Planning Commission Agenda July 20, 2022

RE: 150 Barber Dr. – Hillsdale College Baseball Stadium

HILLSDALE COLLEGE BASEBALL STADIUM, ISSUED FOR CONSTRUCTION, 06/30/22

Plans for the proposed Baseball Stadium for Hillsdale College located at 150 Barber Dr. were reviewed by the City Dept. Heads on July 7, 2022. Their comments are as follows:

07/13/22
 Sheet
C-4

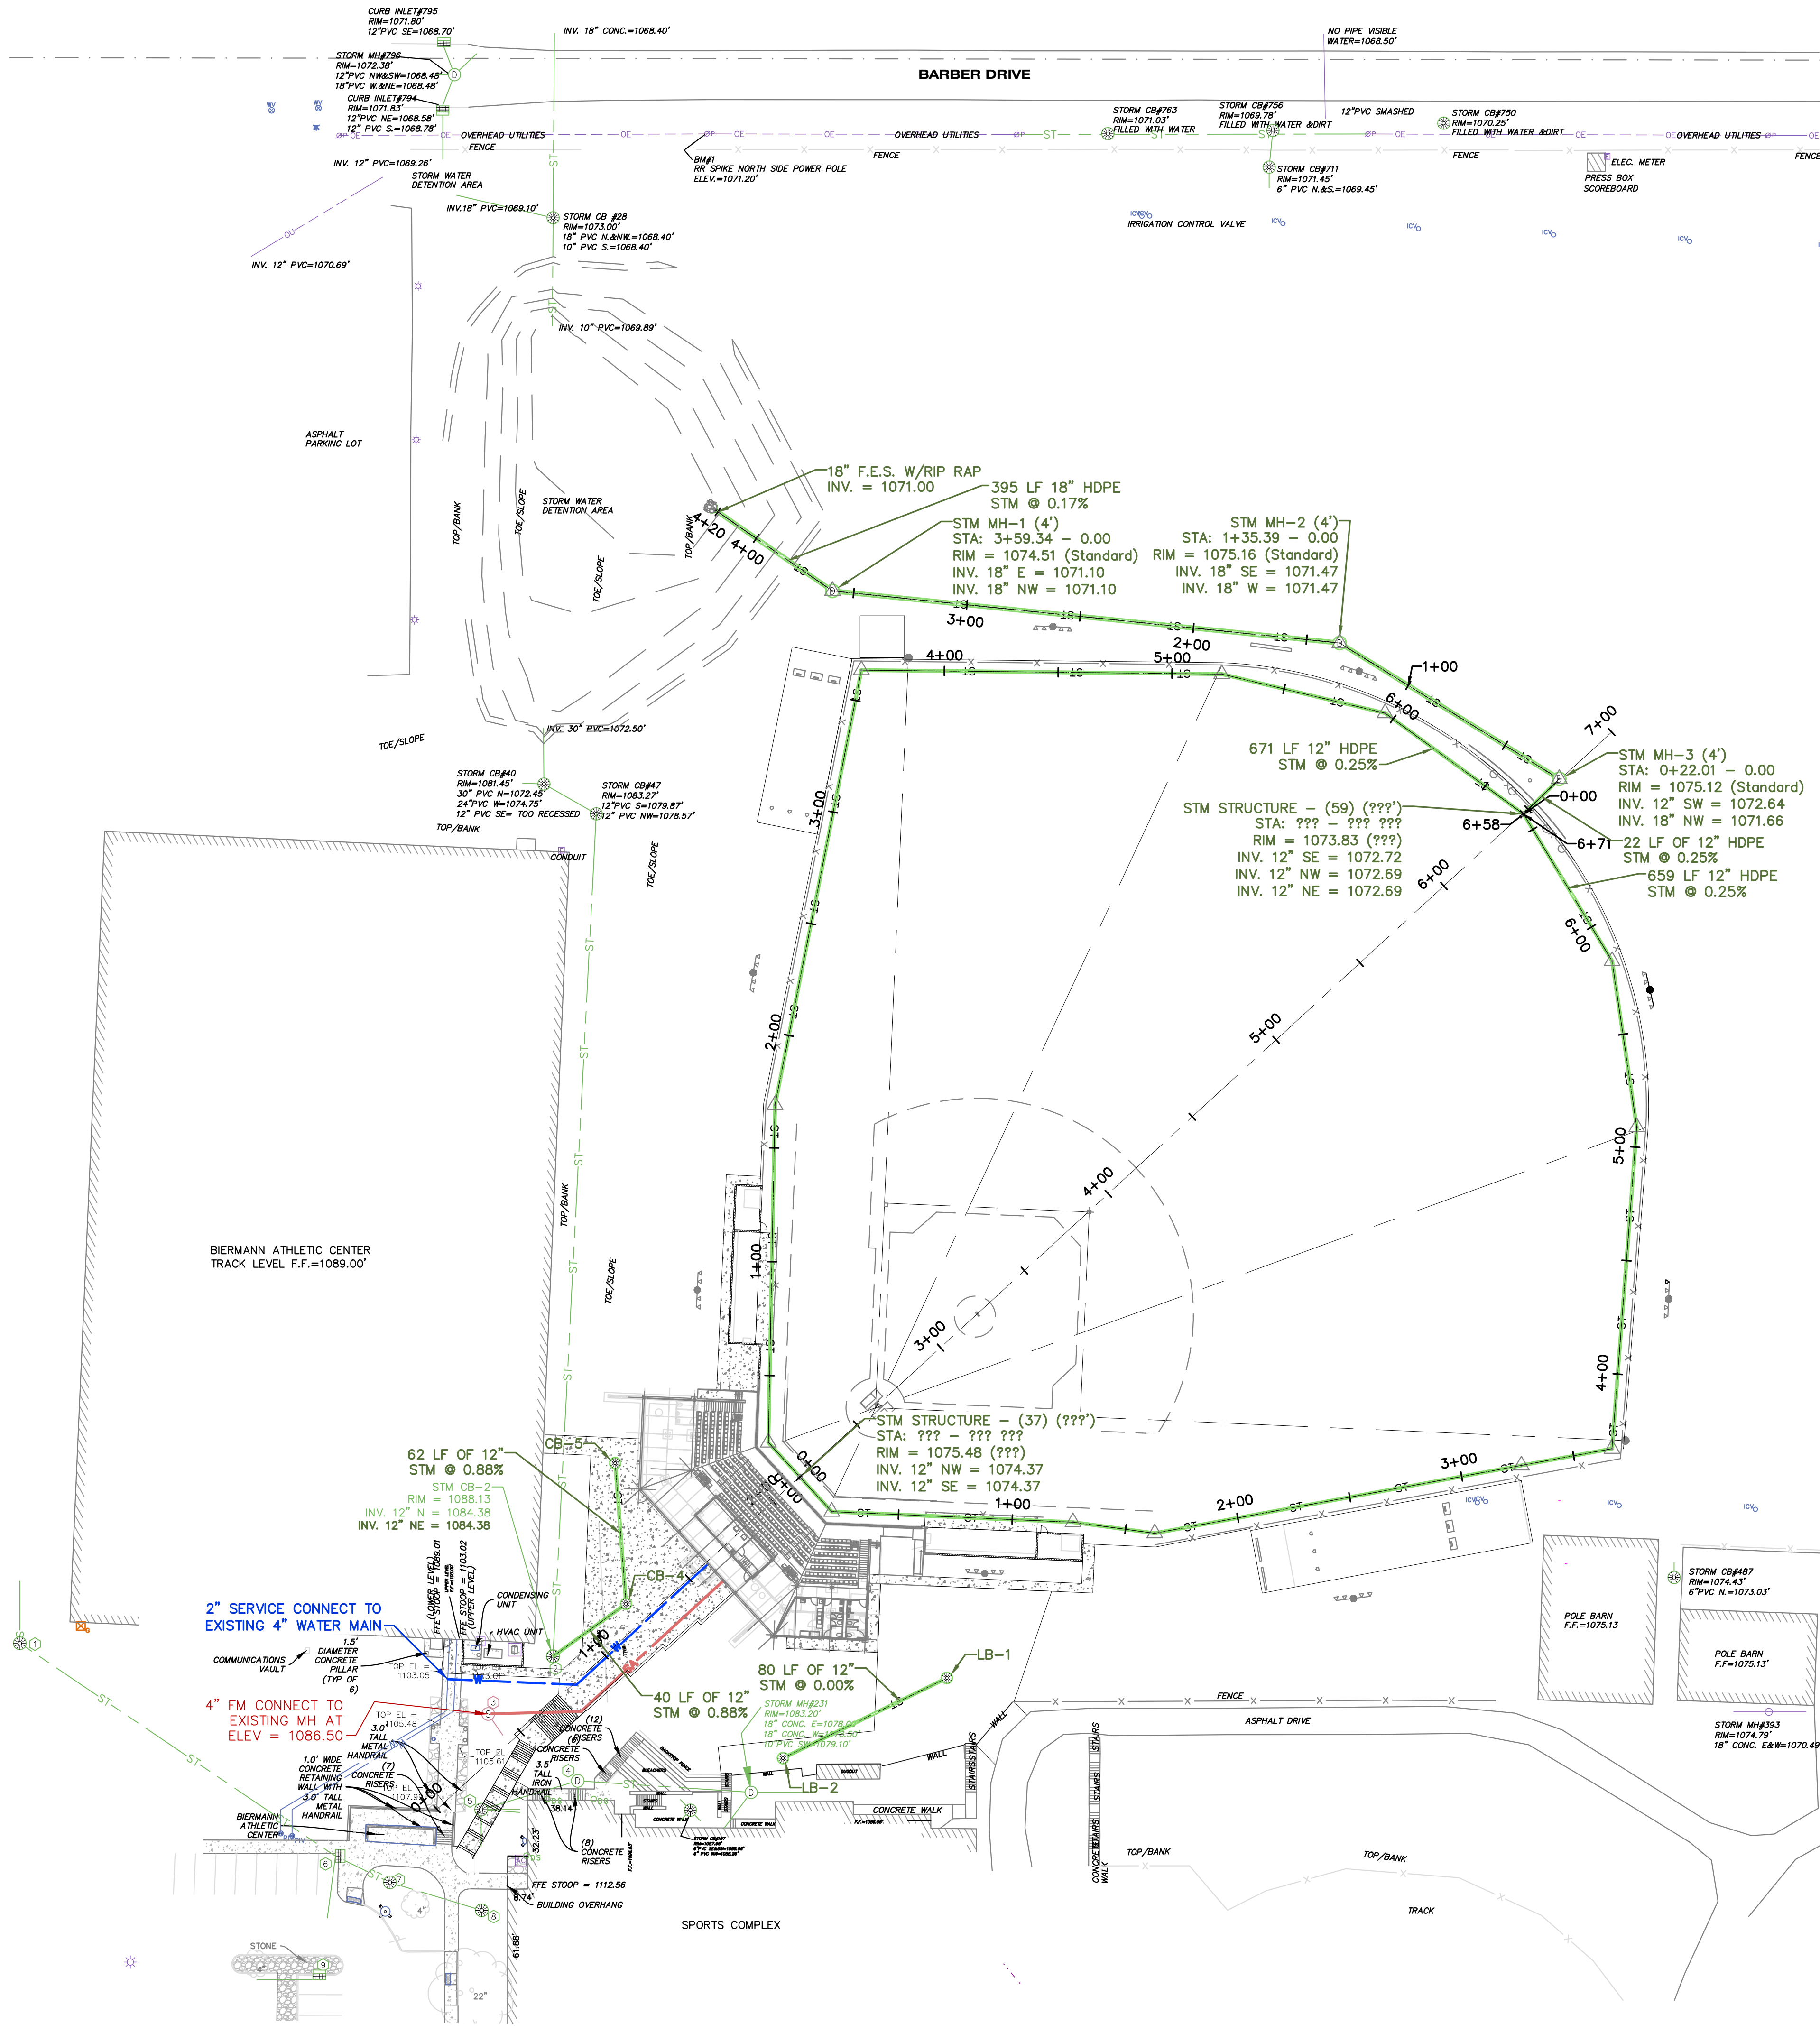
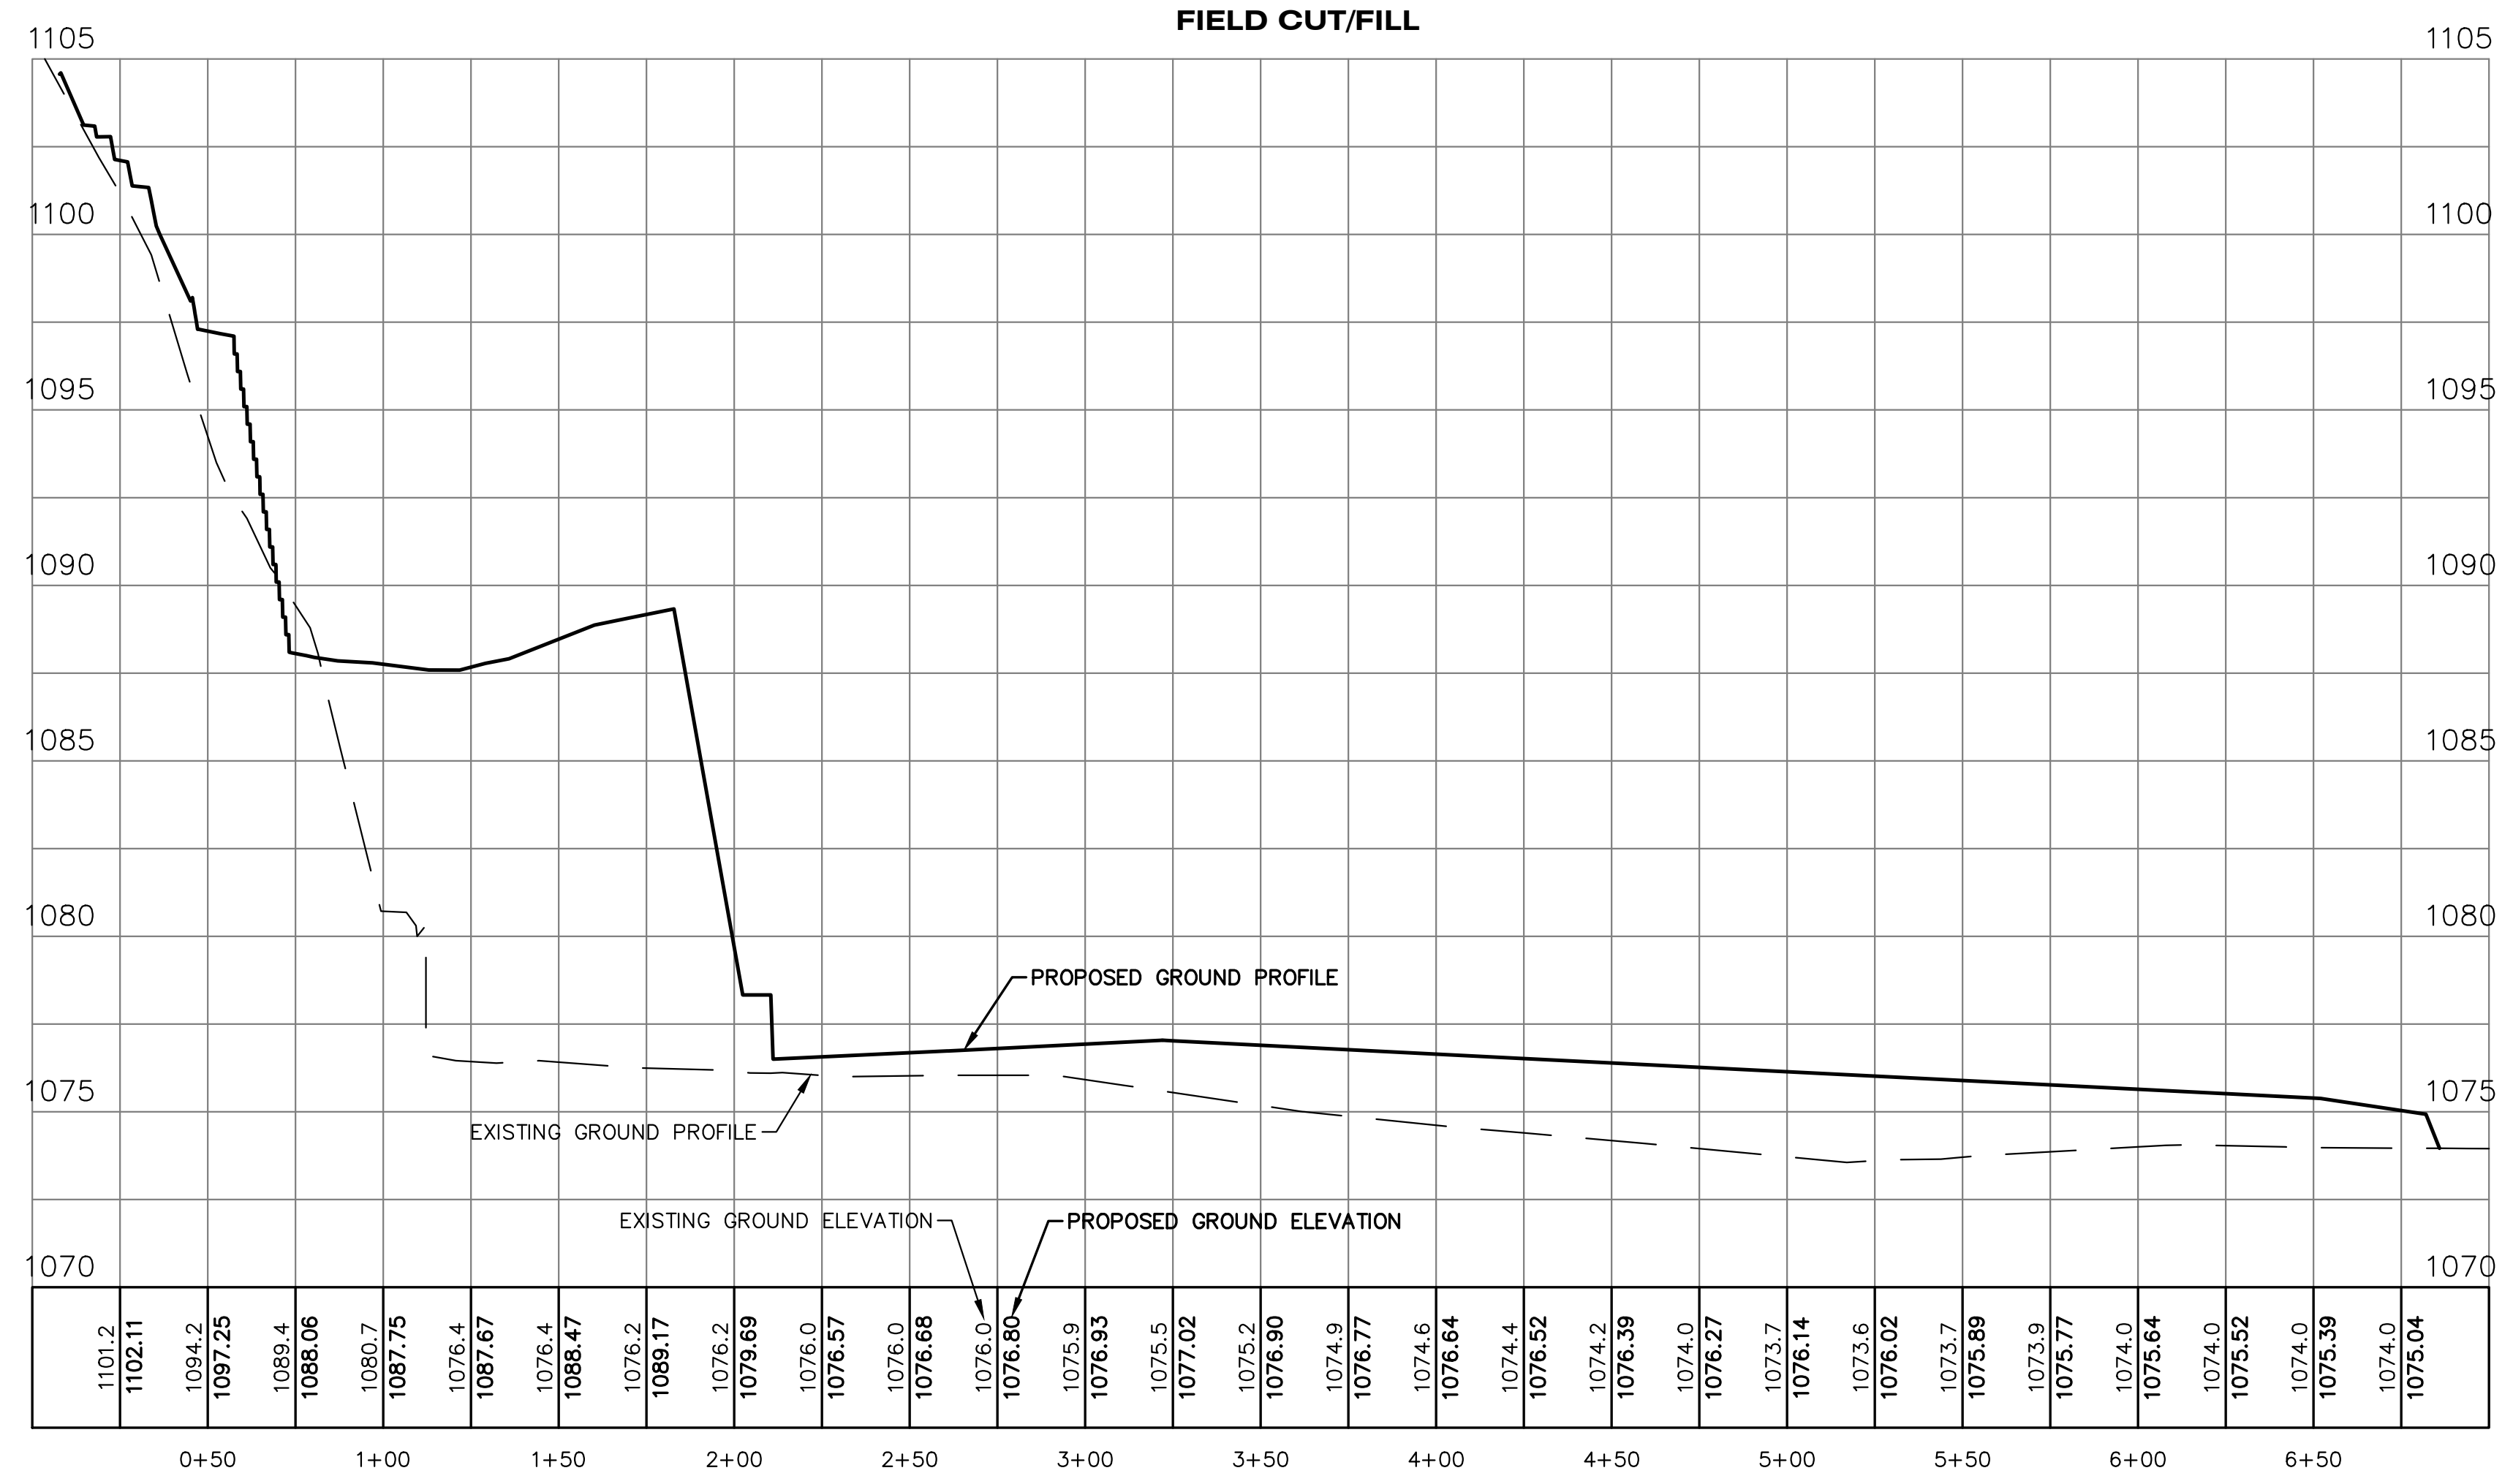
- Add notes to the drawings to jet the existing storm system following completion of the project.
- Add notes to bag the catch basins during construction.

8. JET THE EXISTING STORM SYSTEM FOLLOWING COMPLETION OF THE PROJECT.
9. ADD SILT SACKS TO EXISTING STORM CATCH BASINS BEFORE CONSTRUCTION.
